REMARKS

This application pertains to a novel bandage for the shoulder and upper arm area. Claims 1-20 are pending.

Figure 3

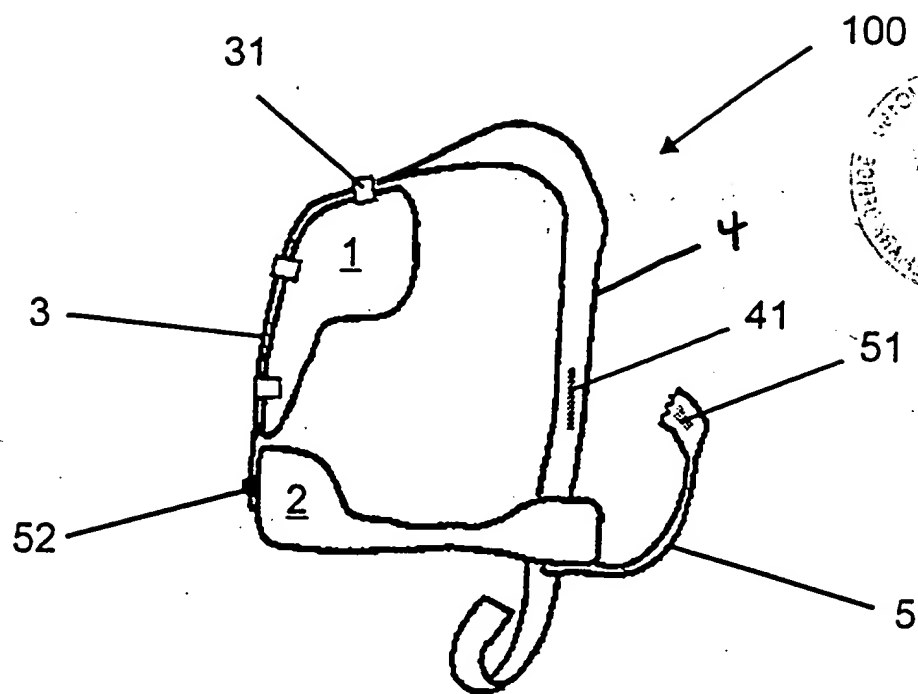
Applicants also respectfully request consideration and approval of the proposed corrections shown in red on the enclosed copies of Figures 3 and 4. The correction in each case is the addition of a designating line "4" to identify the shoulder strap. Support is found at page 8, line 10.

The bandage 100 shown in Figure 3 is made up essentially of the upper arm part 1 and the forearm part 2, which are connected to one another in a substantially flexible manner via an appropriately shaped connection strap [5] **3**. The connection strap 3 is secured on the upper arm part 1 by means of [velcro] **VELCRO® hook and loop** closures, and the connection to the forearm part 1 is effected by a press stud 52. The securing by [velcro] **VELCRO® hook and loop** closures [51] **31** ensures that the bandage can be adapted to the individual circumstances of the patient's arm.

Figure 5

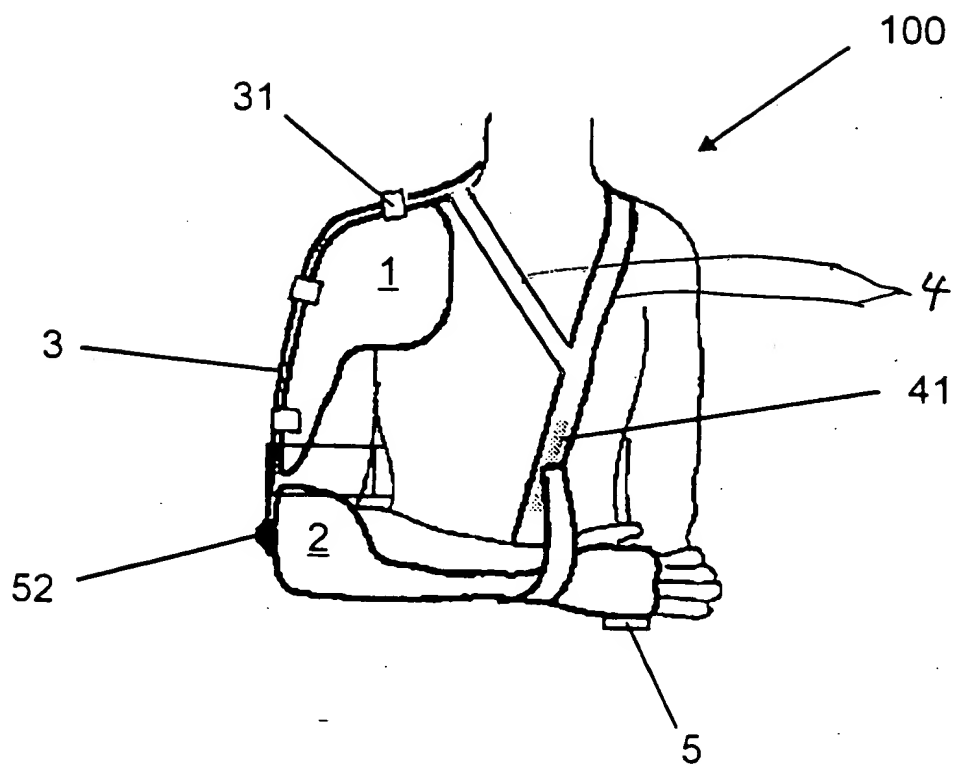
The drawings stand objected to because the support strap designed partially divided in two parts immediately after the attachment point on the shoulder cap as recited in claim 9 must be shown.

Applicants have now provided a proposed new Figure 5 which illustrates that which is described in the foregoing sentence. Figure 5 shows the bandage applied as shown in Figure 4, wherein the support strap 4 is partially divided into two parts, one part shown running ventrally over the thorax and the other part running dorsally over the thorax (illustrated by broken lines). No new matter is added, as the drawing illustrates only that which is disclosed in the original specification, as discussed above.

Not approved
9-24-02-CP
